Quality Alert – Seat Sling for Select ExoFit™ Harnesses

Only Affects select ExoFit™ harnesses manufactured from June 2017 to the end of May 2018

Representative Seat Sling Indicated by Red Arrow

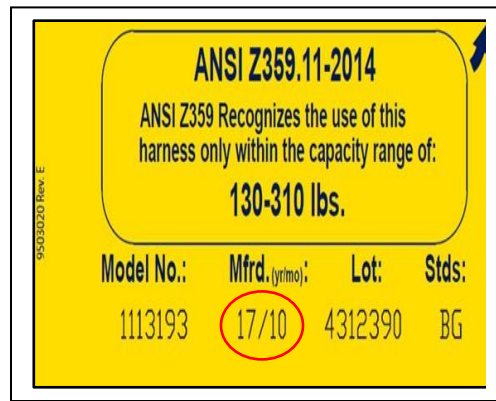
3M Fall Protection has received reports that the aluminum reinforcement plate used in the seat sling on certain DBI-SALA ExoFit™, ExoFit XP™ (inc. Arc Flash), and ExoFit NEX™ (inc. Arc Flash) harnesses can become dislodged from the webbing. In a few instances, the aluminum seat plate has separated from the harness and fallen to the ground, creating a potential dropped object hazard. There have been no reports of injuries or accidents associated with this condition. The performance of the harnesses is unaffected by this issue—they will perform properly in all respects, including as body support for a personal fall arrest system in the event of a fall, even without the added comfort offered by the seat sling.

Manufacture Date on Harness shown in Red Circle

3M is offering a free warranty replacement of the seat sling for all DBI-SALA ExoFit™, ExoFit XP™ (inc. ArcFlash), and ExoFit NEX™ (inc. ArcFlash) harnesses with a seat sling, with a manufacture date of 17/06 (2017, June) through the end of 18/05 (2018, May) regardless of model number.

End-Users: Please inspect your harness, if you find a harness within the affected range with a seat sling, contact 3M Customer Service at 1-800-328-6146 or email us for your free replacement seat sling at 3musfbserviceaction@mmm.com. Please provide us with the model number and manufacture date when contacting us. After you receive your replacement seat sling, please remove your original sling from service and dispose of it.

La flecha roja señala la eslinga de asiento del ejemplo

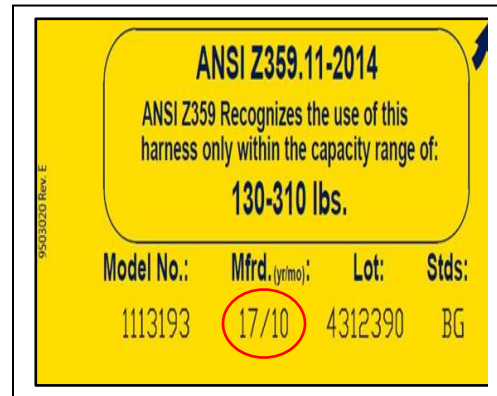
3M Fall Protection ha recibido informes que indican que la placa de refuerzo de aluminio que se usa en la eslinga de asiento puede desprenderse del tejido trenzado en ciertos arneses ExoFit™, ExoFit XP™ (incluyen los modelos para arco eléctrico) y ExoFit NEX™ (incluyen los modelos para arco eléctrico) DBI-SALA. En algunas circunstancias, la placa de asiento de aluminio se ha separado del arnés y se ha caído al suelo, lo que crea el peligro posible de una caída de un objeto. No hemos recibido ningún informe de lesiones o accidentes asociados con esta condición. El desempeño de los arneses no se ve afectado por este problema, por lo que cumplirán correctamente con su propósito en todo momento, hasta como sujeción del cuerpo para un sistema de detención de caídas personal en caso de que se produzca una caída, incluso sin la comodidad adicional que ofrece la eslinga de asiento.

El círculo rojo muestra dónde se encuentra la fecha de fabricación en el arnés

3M ofrece, como parte de la garantía, un reemplazo sin cargo de la eslinga de asiento para todos los arneses ExoFit™, ExoFit XP™ (incluyen los modelos para arco eléctrico) y ExoFit NEX™ (incluyen los modelos para arco eléctrico) DBI-SALA, con una fecha de fabricación entre 17/06 (junio de 2017) y fines de 18/05 (mayo de 2018) independientemente del número de modelo.

Usuarios finales: Inspeccionen el arnés. Si ven que un arnés con eslinga de asiento se encuentra en el grupo de arneses afectados, comuníquense con el Servicio al cliente de 3M llamando al 1-800-328-6146 o envíenos un correo electrónico a 3musfbserviceaction@mmm.com para solicitar el reemplazo sin cargo alguno de la eslinga de asiento. Cuando se comuniquen con nosotros, proporcione el número de modelo y la fecha de fabricación. Una vez que reciba la eslinga de asiento de reemplazo, retire la eslinga original del servicio y descártela.
